DeKalb County Historic Preservation Commission

Staff Report

E. 971 Oakdale Road, FIELD Landscape Architecture. Install landscaping. **1247562**

August 2025

L-1.00

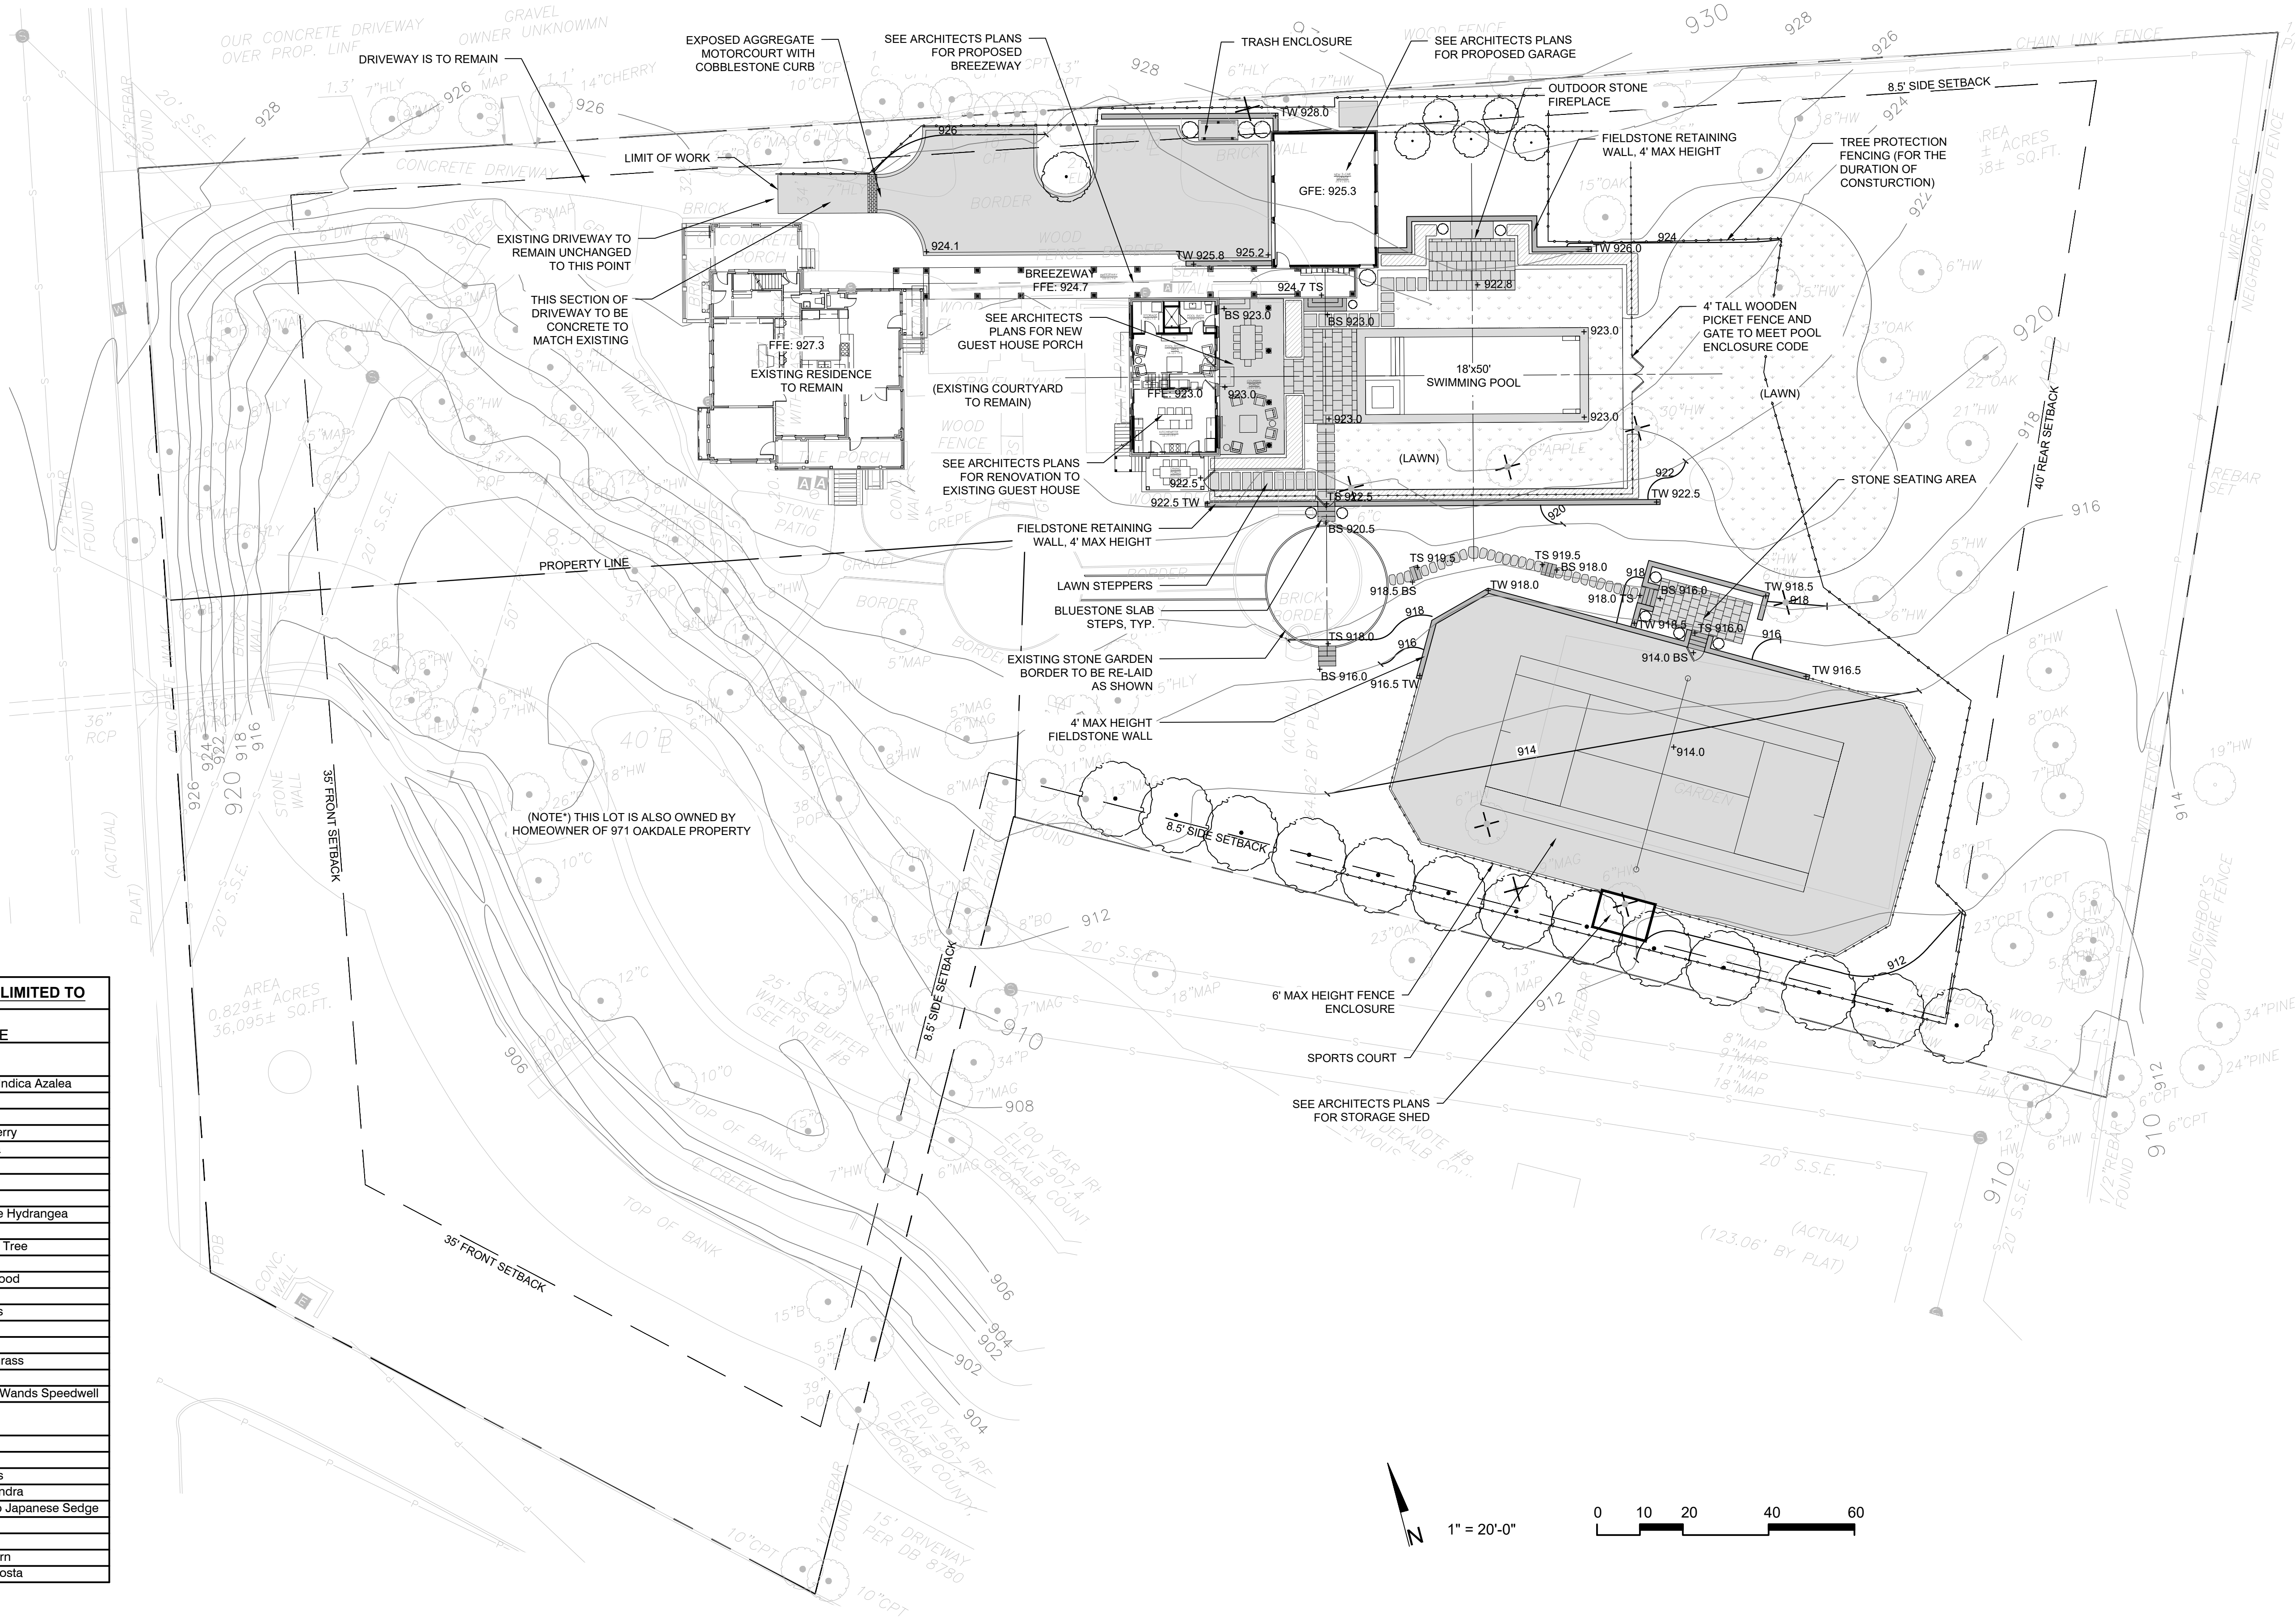
2. The current proposed site plan does not show the neighboring properties; can you provide an updated site plan to show the neighboring properties and their proximity to the proposed work? - [Neighboring properties have been outlined and added to the site plan.](#)

6. What are the proposed modifications to the existing driveway? Will the driveway be expanded or reduced, and if so, what is the current size of the driveway and how will its size be modified? - The existing driveway is a total of 4,458SF, and the proposed size after modifications will be 3,843SF. The existing driveway will remain unchanged up to the point of the existing covered porch corner, approximately. After this point, the existing driveway is to be removed and the footprint reduced and modified to connect to the newly proposed garage. The adjustments to the driveway can be seen between the existing survey and the hatched design on L-1.00.

EXTERIOR
ELEVATIONS
- PROPOSED

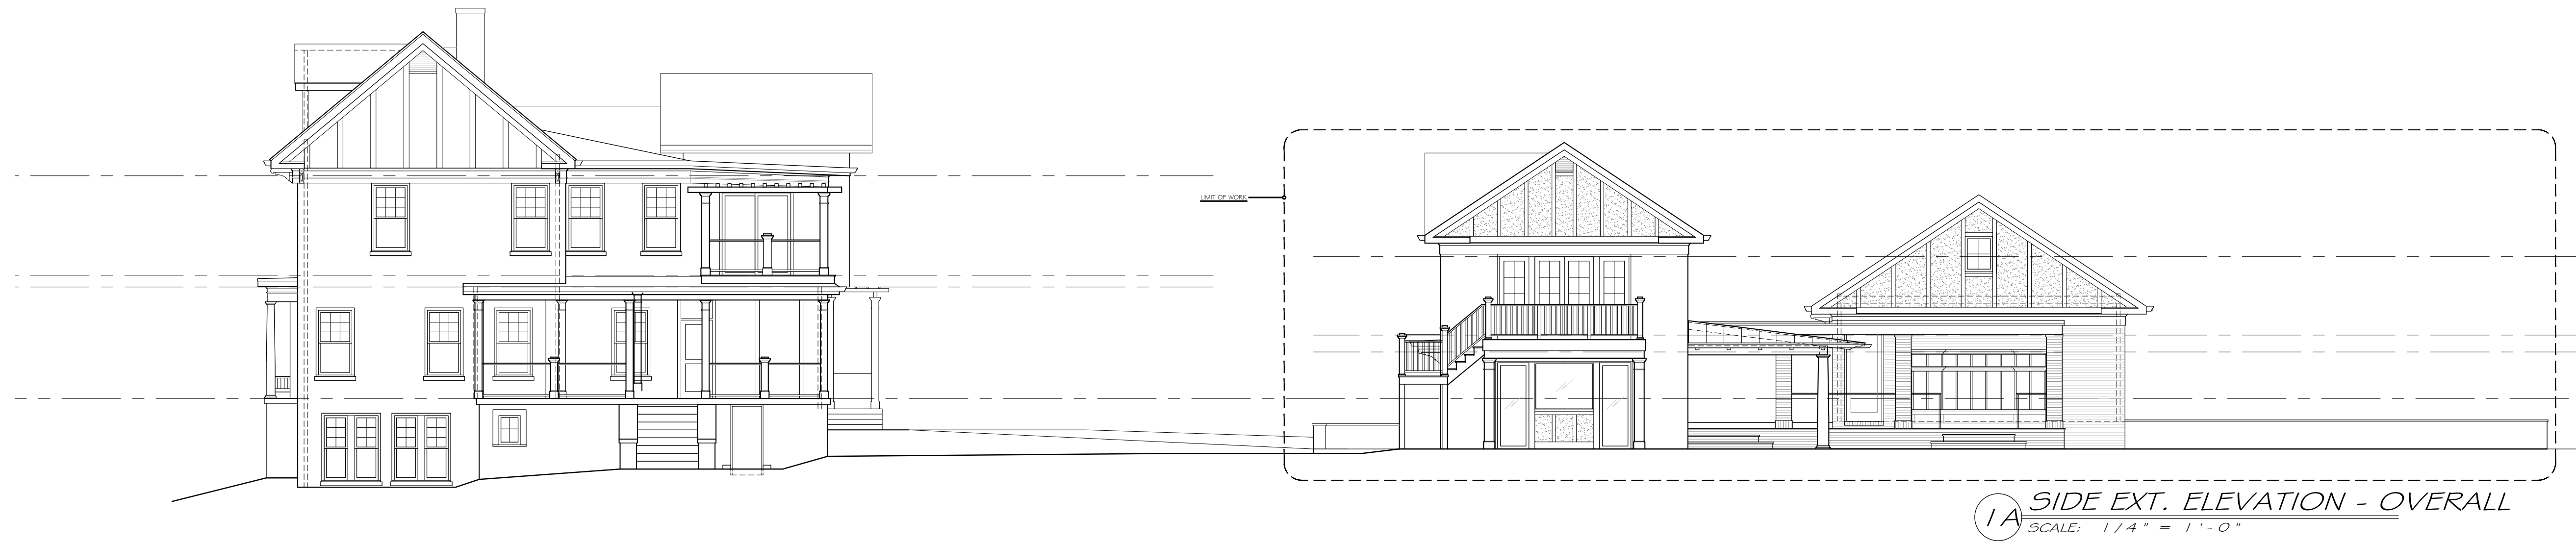
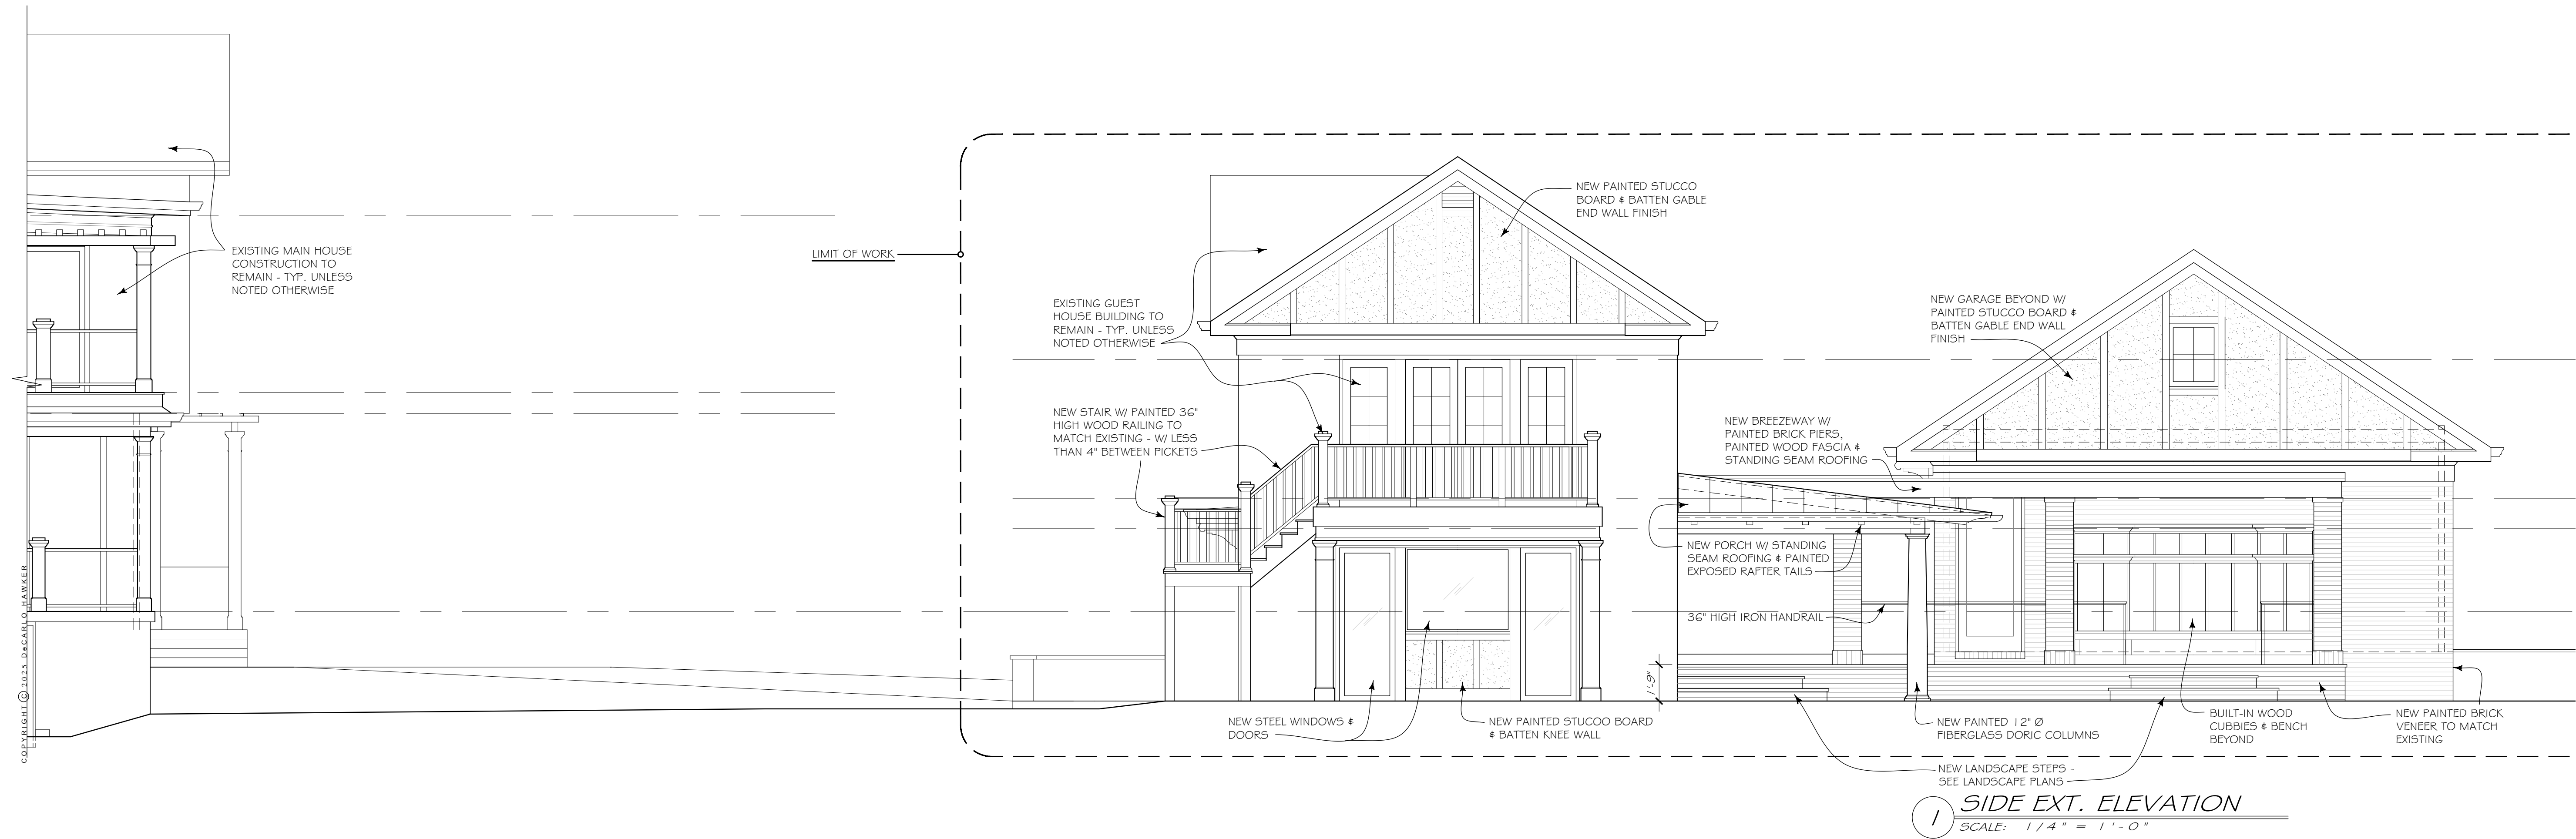
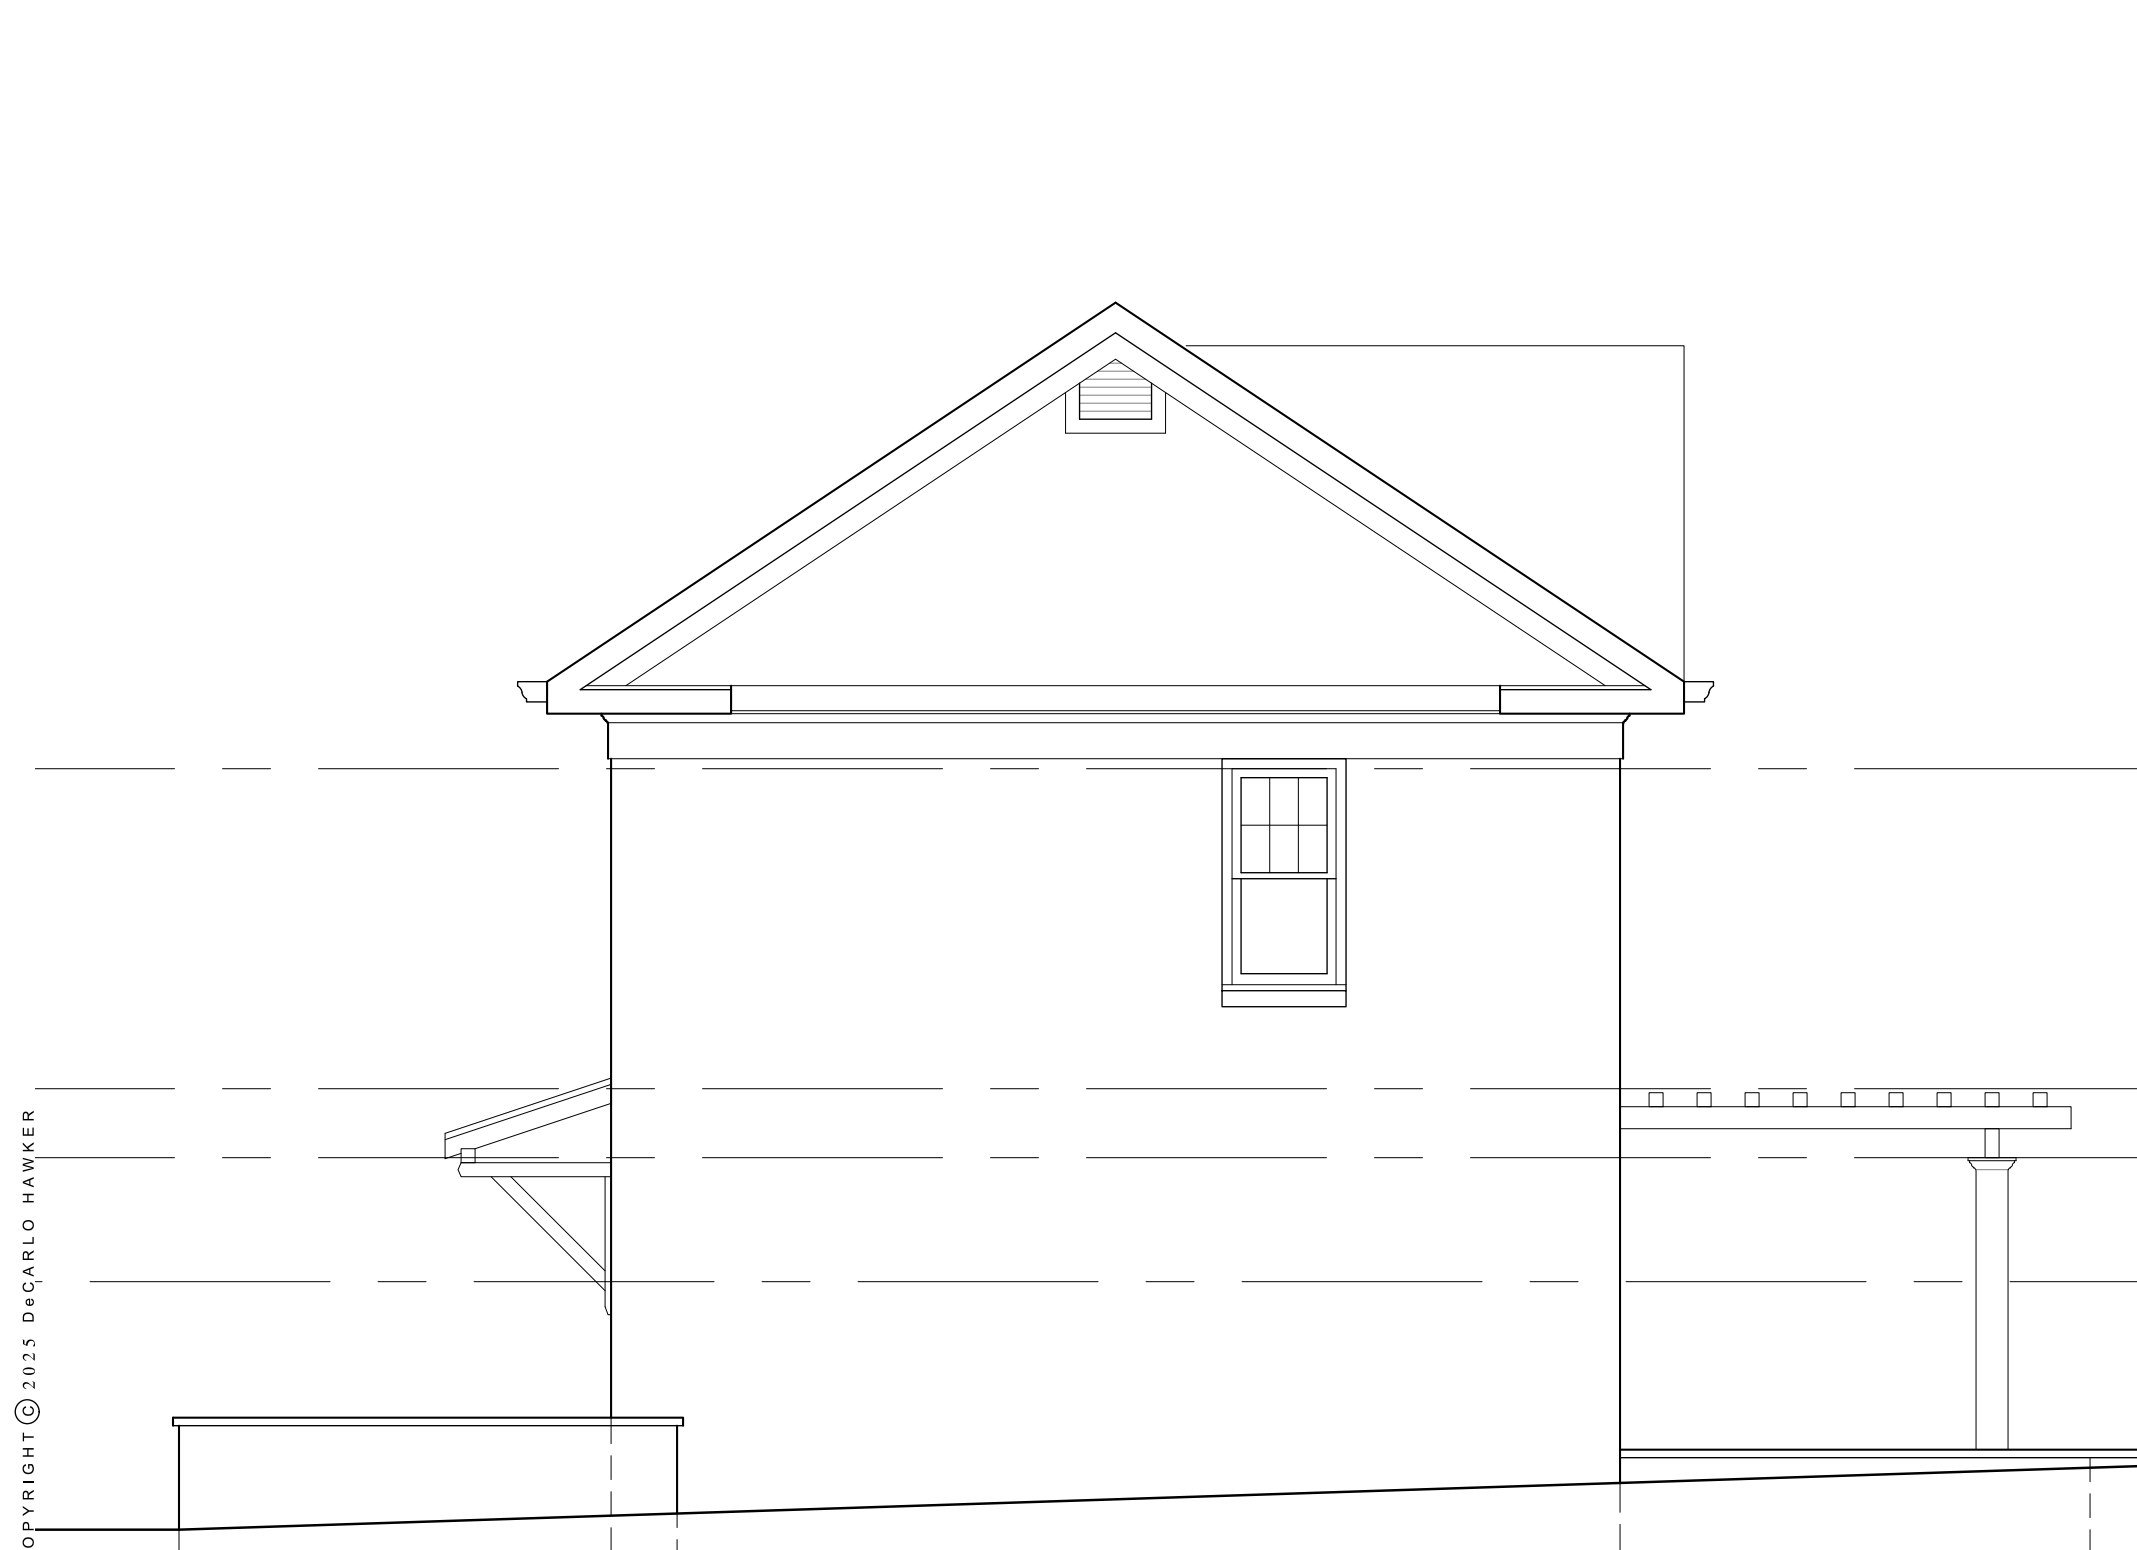
1. Can you provide individual drawings to show the existing and proposed elevations of the renovated guest house with notes regarding the proposed changes in the exterior materials and design? - [Please refer to sheets A2.4 & A2.5 for existing elevations of the guest house. The elevation drawings and accompanying notes on A2.1 & A2.2 show the existing vs. proposed material and design changes.](#)
